SAFETY AND NO SIGNIFICANT HAZARDS CONSIDERATION EVALUATION

Description of Amendment Request:

Pages 4.8-1 through 4.8-3

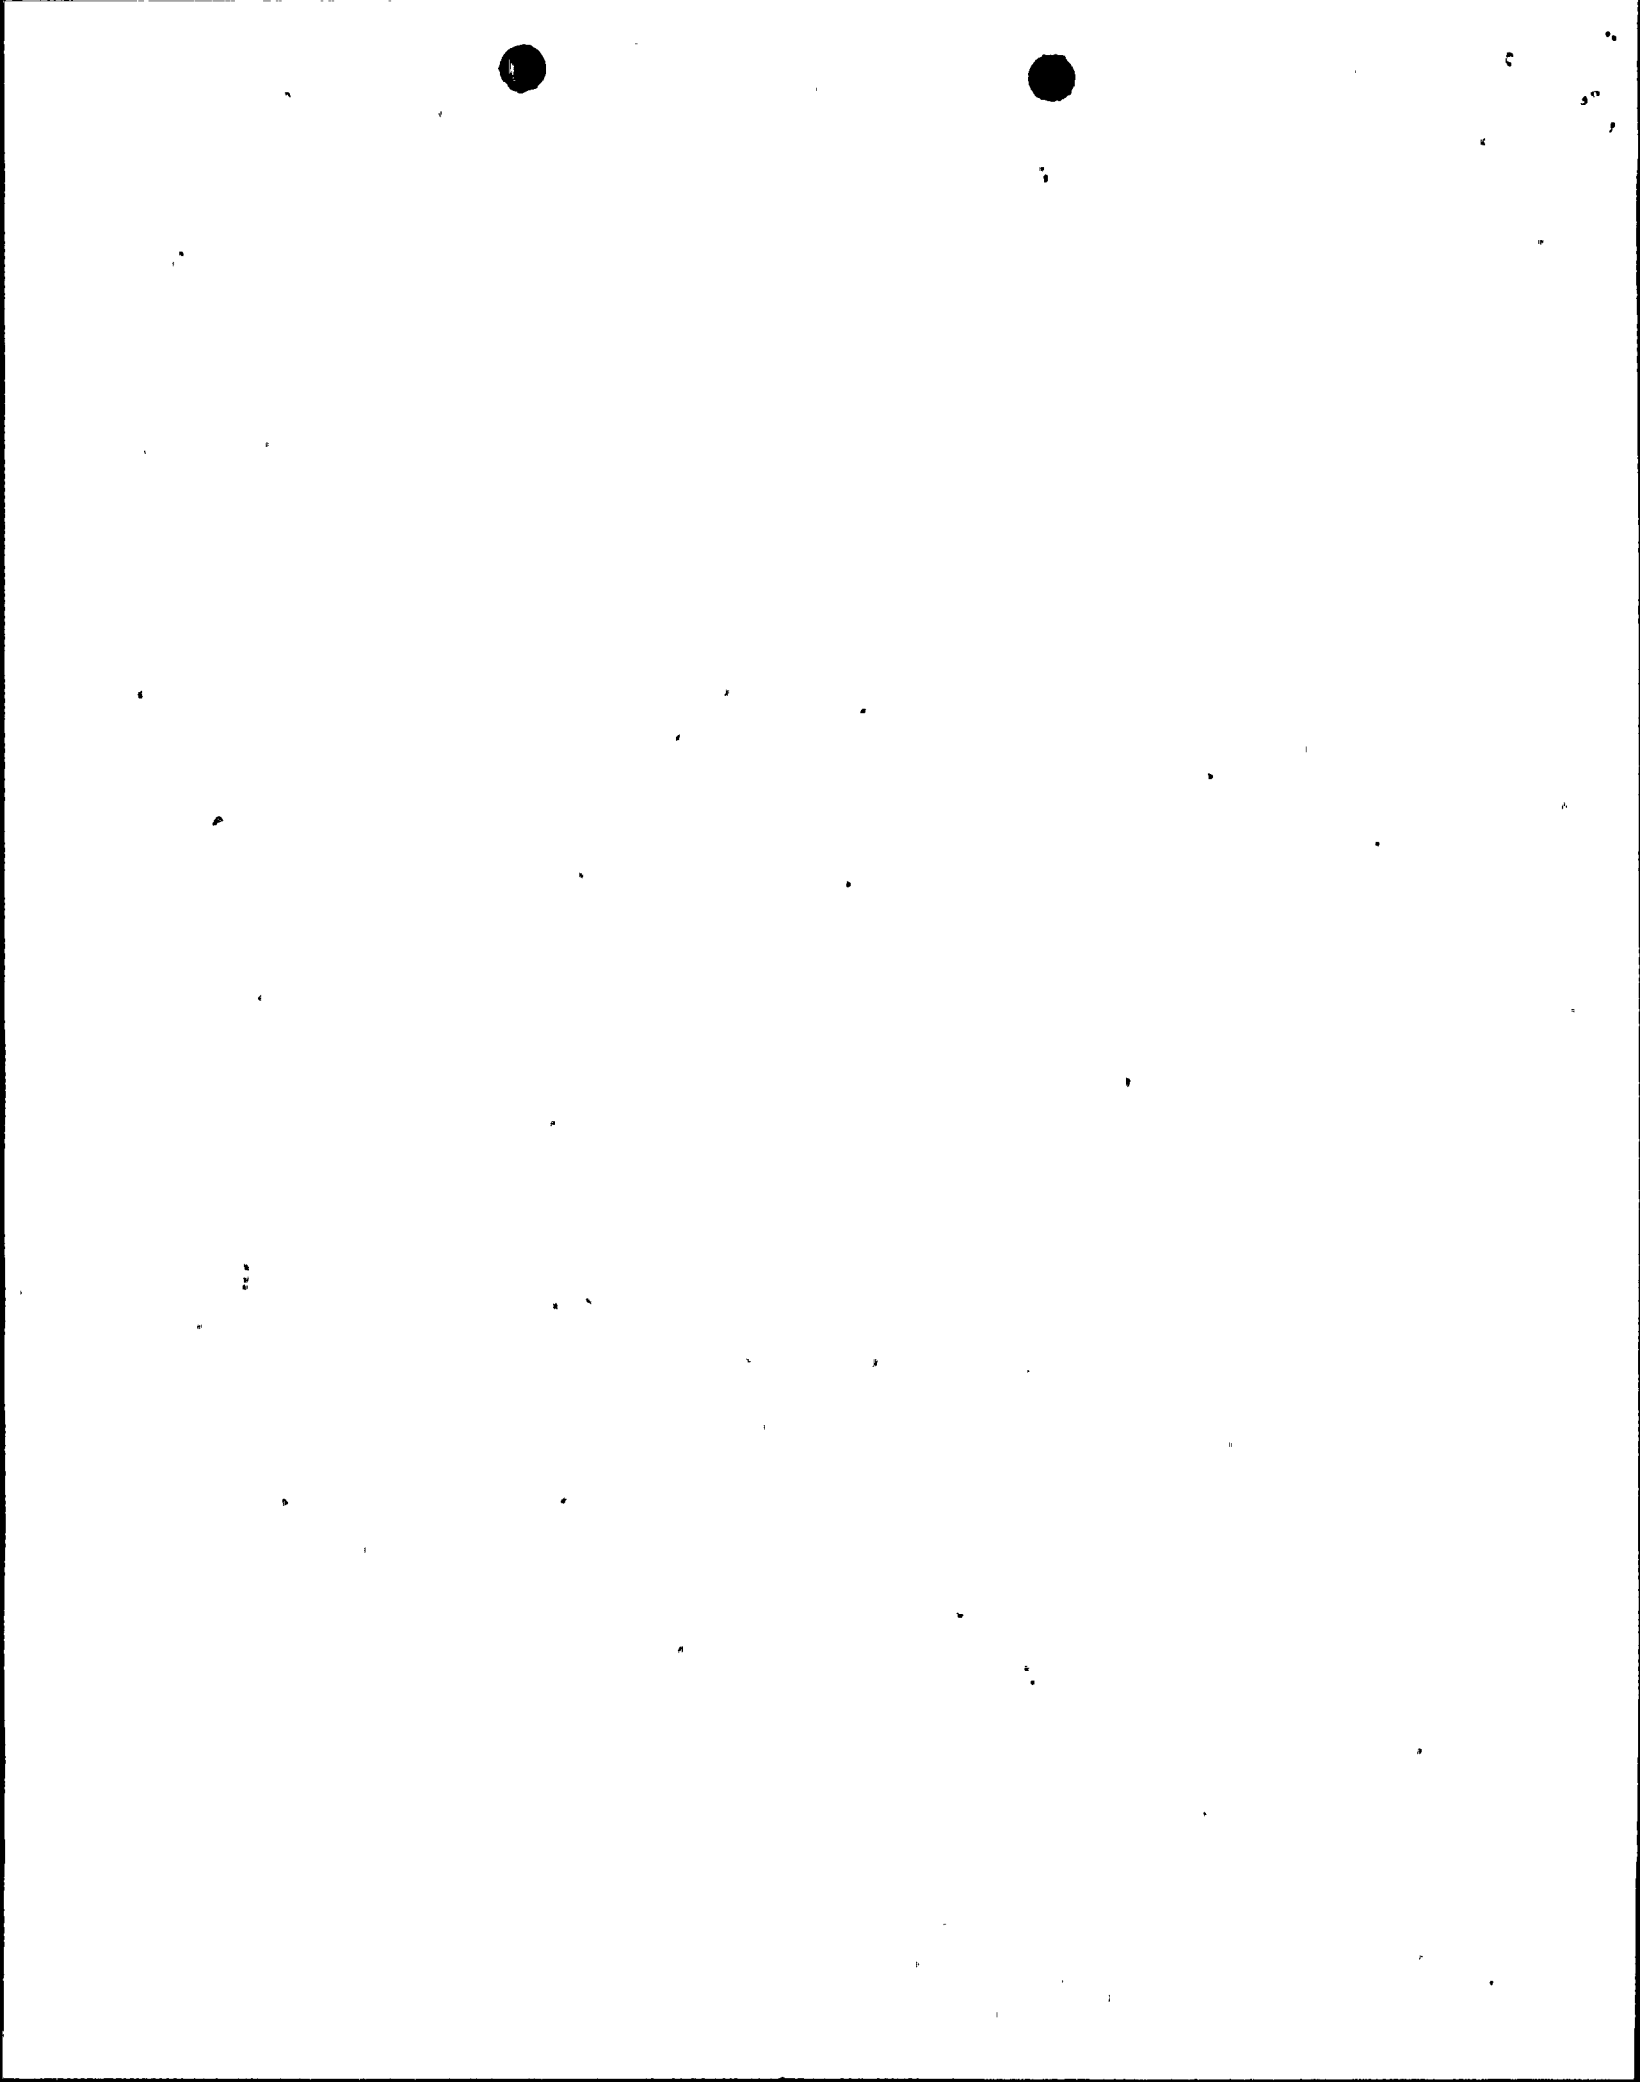
Technical Specification 4.8.1.C.1 requires that each diesel generator be subjected to an inspection in accordance with the manufacturers recommendations at least once each eighteen months. Technical specification 4.0.1 states that interval may be adjusted plus or minus 25% to accomodate normal test schedules. This inspection was last completed on the "A" and "B" diesel generators on December 23, 1984 and January 13, 1985 respectively. This would require the next inspections to be performed no later than November 11, 1986 and November 27, 1986.

Prior to the startup of Turkey Point Unit 4 from the last refueling outage, Region II requested that FPL defer performing the eighteen month inspections until the Unit 3 refueling outage, scheduled to begin March 1987. The Region wants the inspections to be done with only one unit at power, although the current technical specifications would allow a diesel to be taken out of service for the inspection with both units at power.

The proposed change would defer the required inspections until the next Unit 3 refueling outage. Subsequent inspections would then be performed during each succeeding Unit 3 refueling outage.

- c. During each Unit 3 refueling outage by:
1. Subjecting the diesel to an inspection in conjunction with its manufacturer's recommendations for this class of standby service.
